**TOWN OF MOUNTAIN VILLAGE
REGULAR DESIGN REVIEW BOARD MEETING AGENDA
TO BE HELD IN PERSON
THURSDAY NOVEMBER 4, 2021 10:00 AM
MOUNTAIN VILLAGE TOWN HALL
455 MOUNTAIN VILLAGE BLVD, MOUNTAIN VILLAGE, COLORADO
MOUNTAIN VILLAGE TOWN HALL**

3.	10:05	5	Haynes	Action	Approval of the DRB Schedule 2022
4.	10:10	30	Ward/ Applicant	Quasi-Judicial	Consideration of a Design Review: Final Architecture Review for a new Single Family Home on Lot 515, 134 Russell Drive, pursuant to CDC Section 17.4.11.

AGENDA ITEM 4
PLANNING & DEVELOPMENT SERVICE
PLANNING DIVISION
455 Mountain Village Blvd.
Mountain Village, CO 81435
(970) 728-1392

2 Address Monument

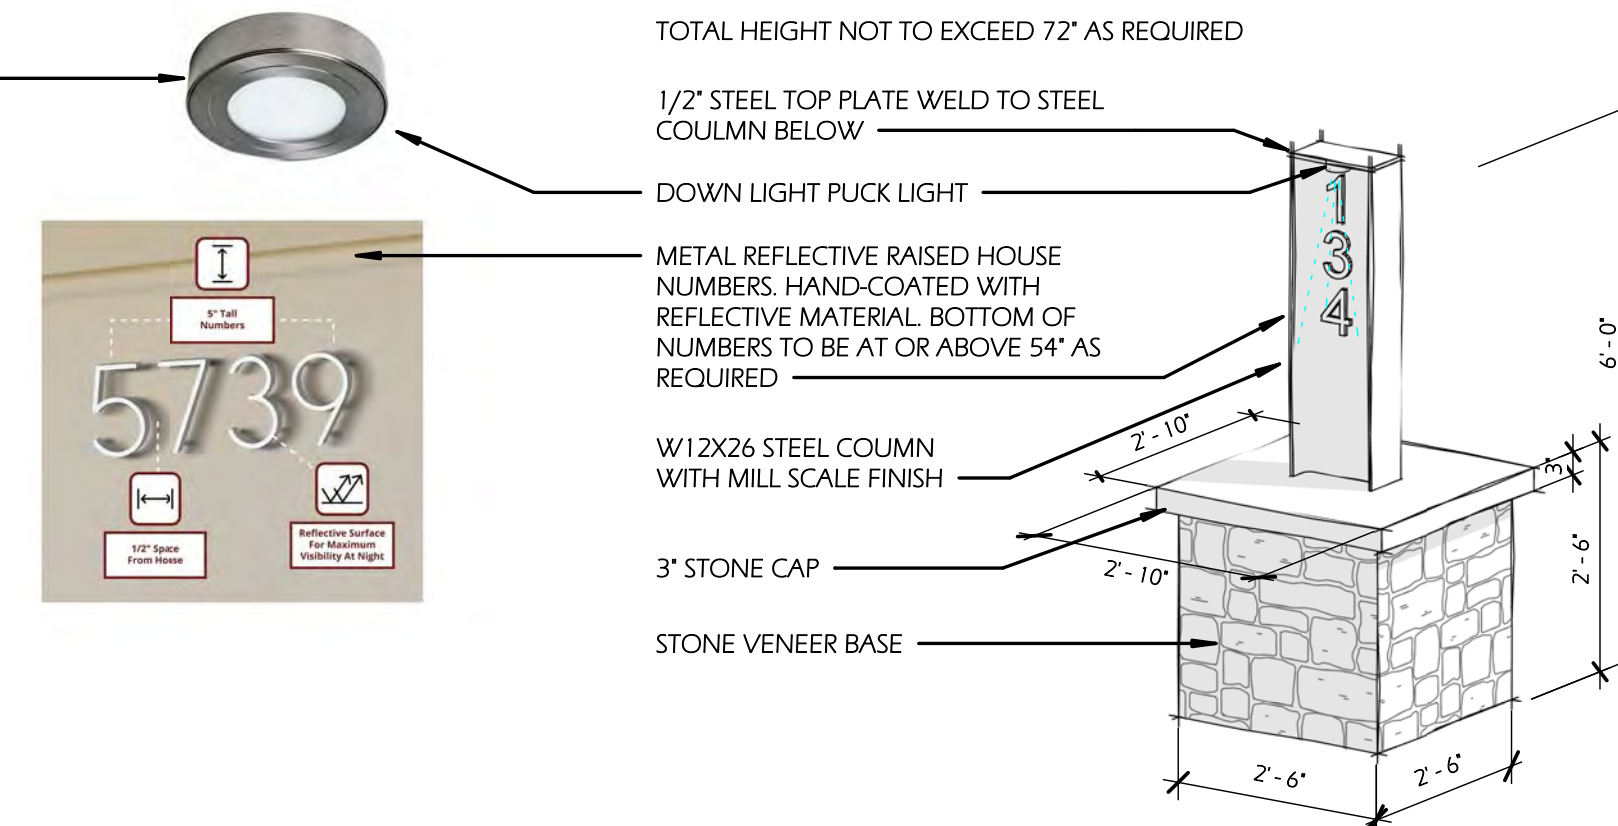
4) Prior to final review, the applicant shall revise the address monument plan to include a lighting specification for the address monument, and to indicate the numerals will be coated with a reflective surface.

Staff: The applicant has revised the specification of the numerals on the address monument to show that they will be treated with a reflective coating as required by the CDC. Staff now finds the monument is in compliance with all CDC regulations.

Please see details on Sheet A3.2 for address monument details.

A 3.5

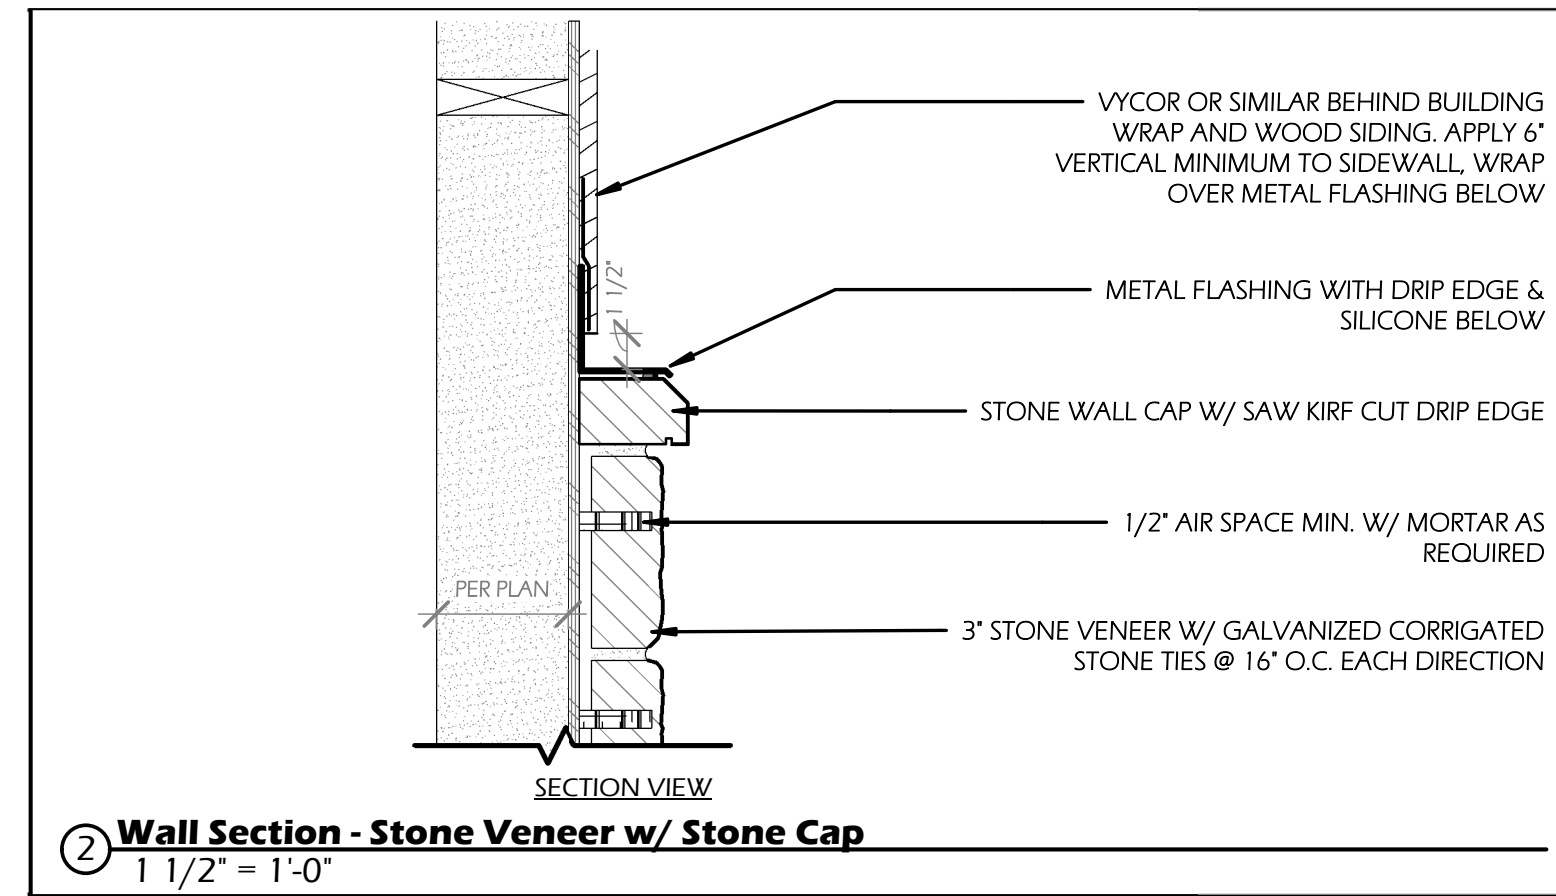
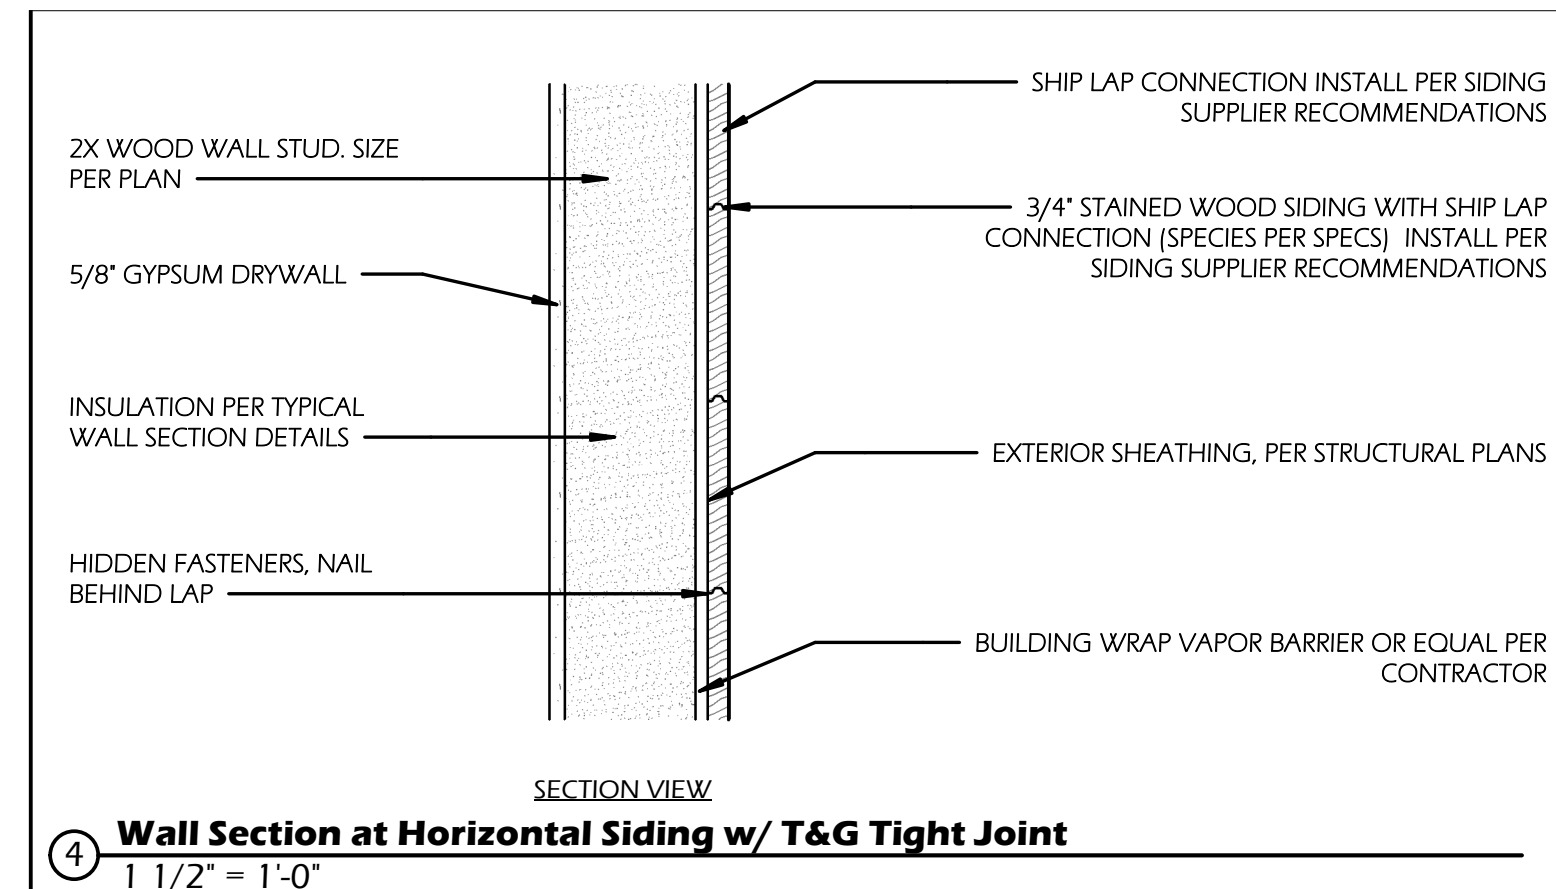
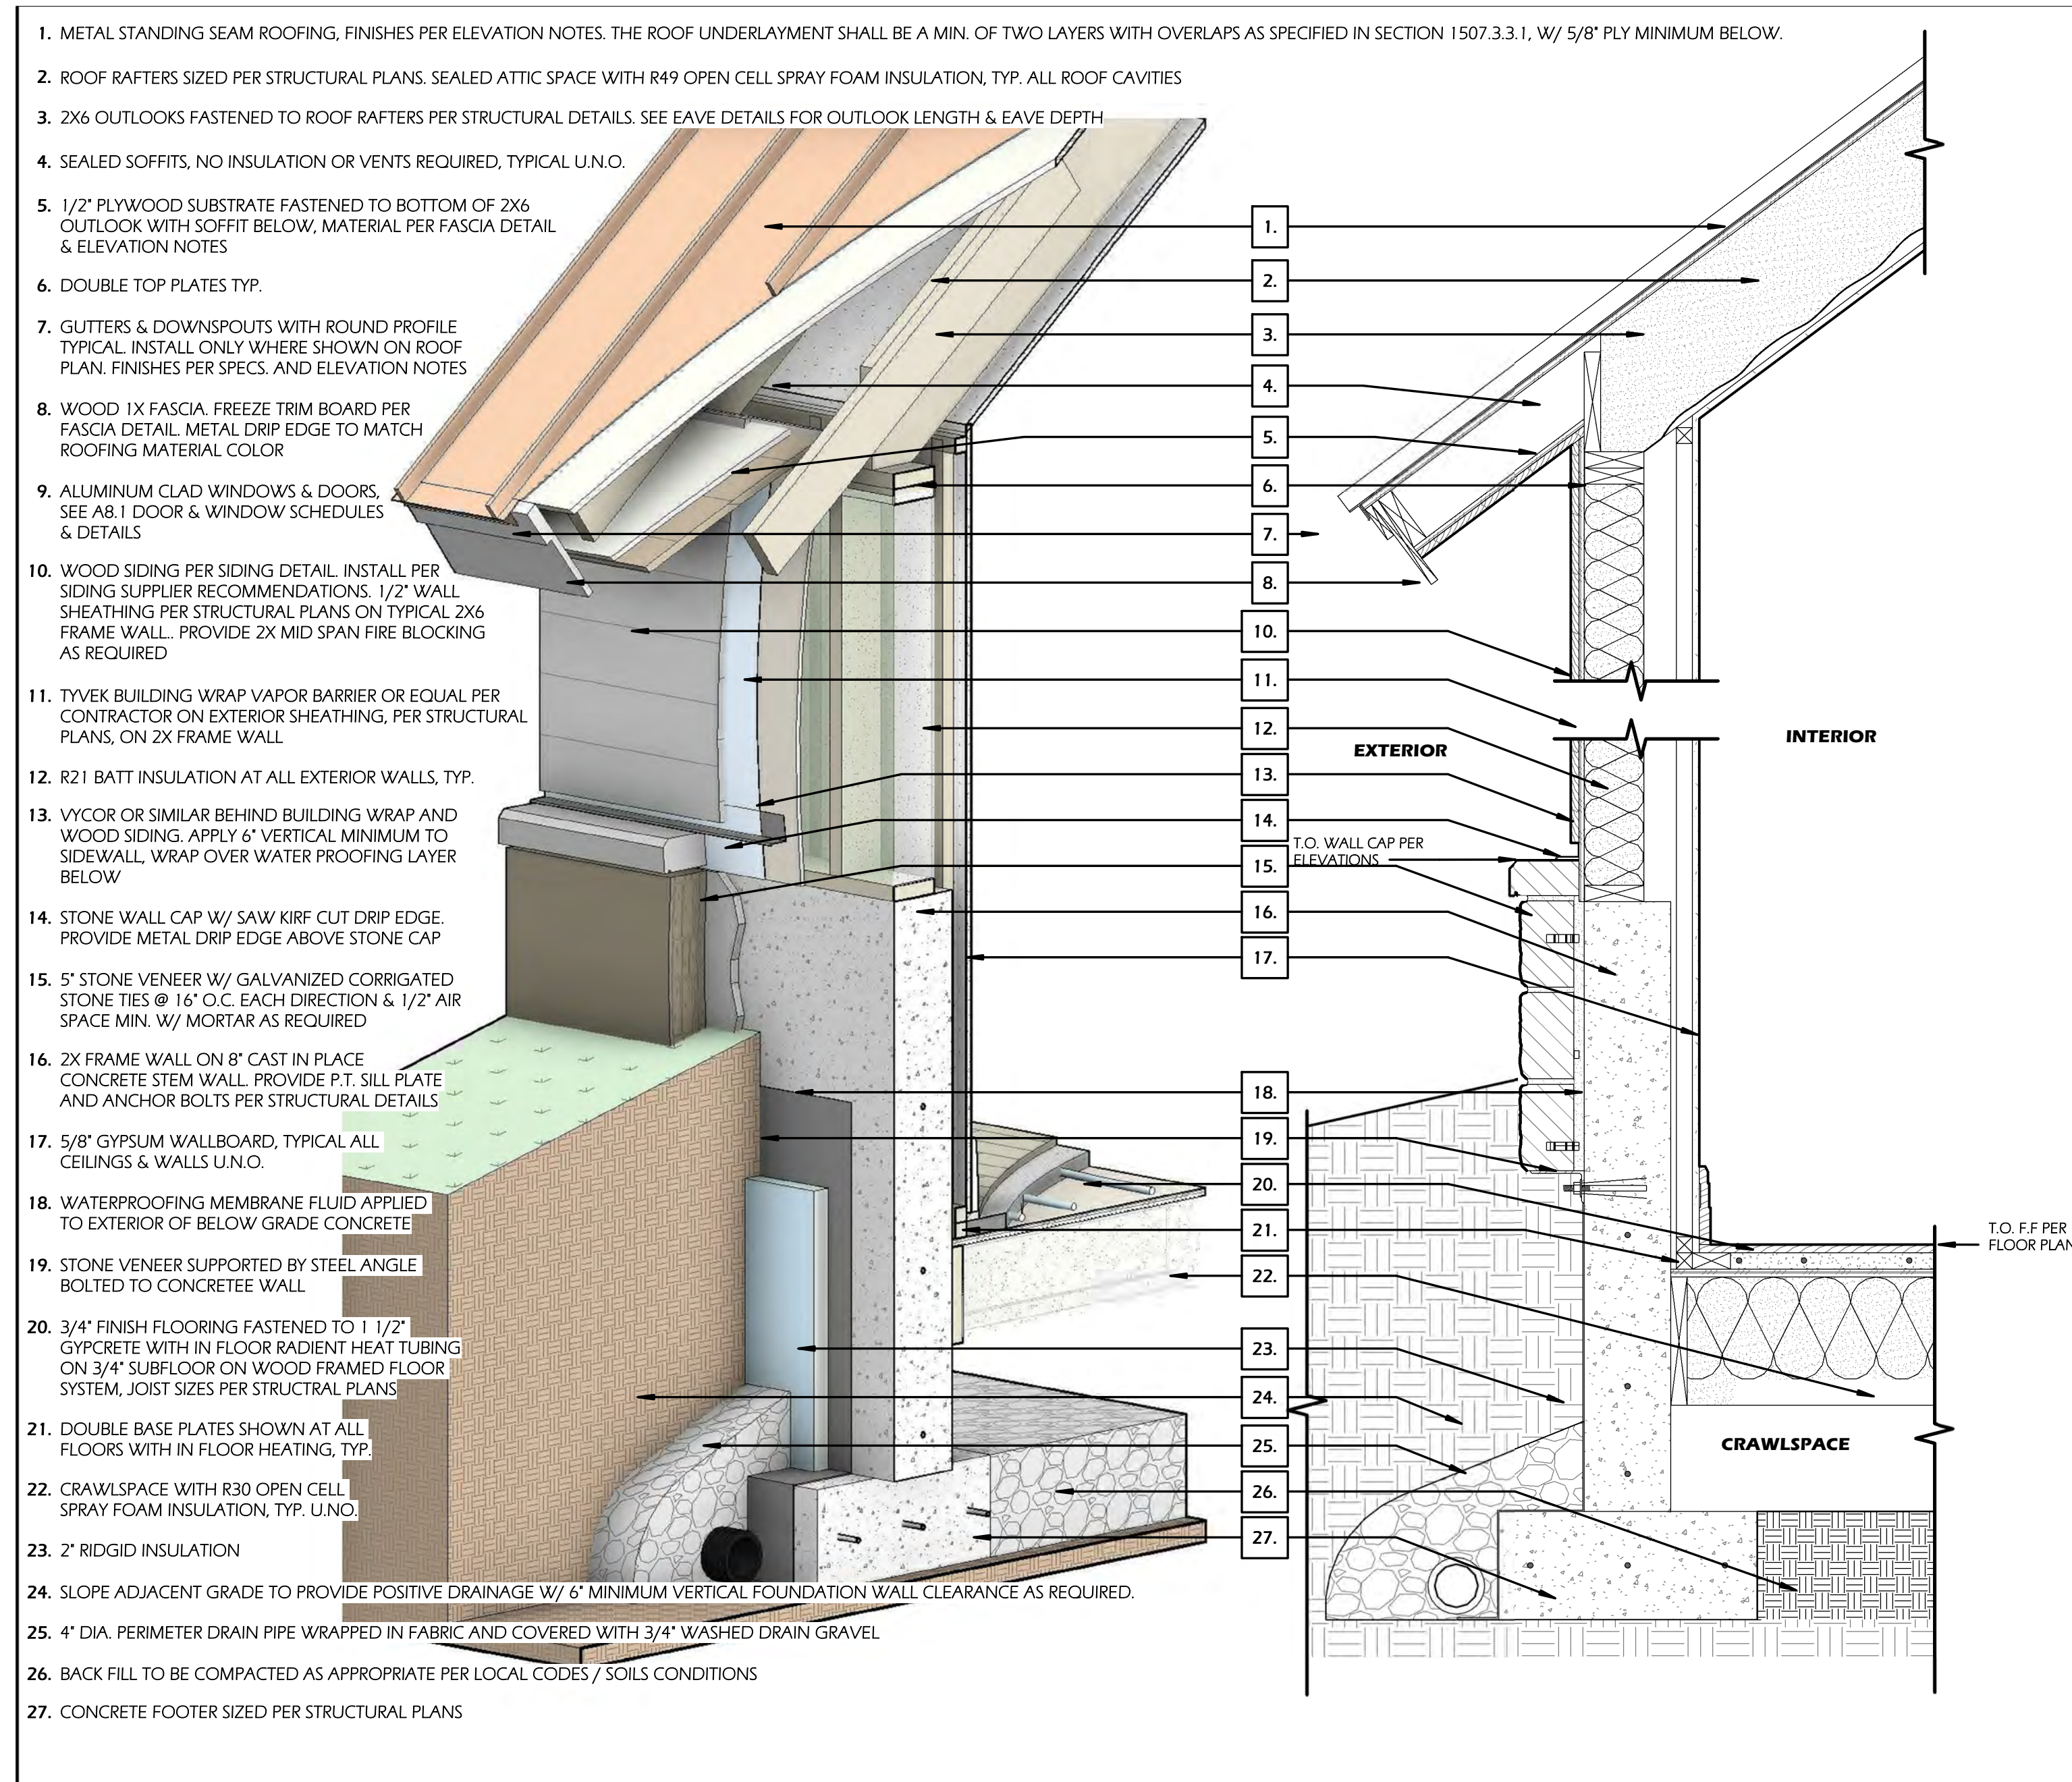
1) Prior to final review, the applicant shall clarify the proposed materials for soffit and fascia and give more detail about the installation of the wood siding.

Sheet A 6.1 details the installation of exterior materials, and includes the additional details requested at Initial Review.

Please see details on Sheet A6.1 for all soffit, fascia and siding details.
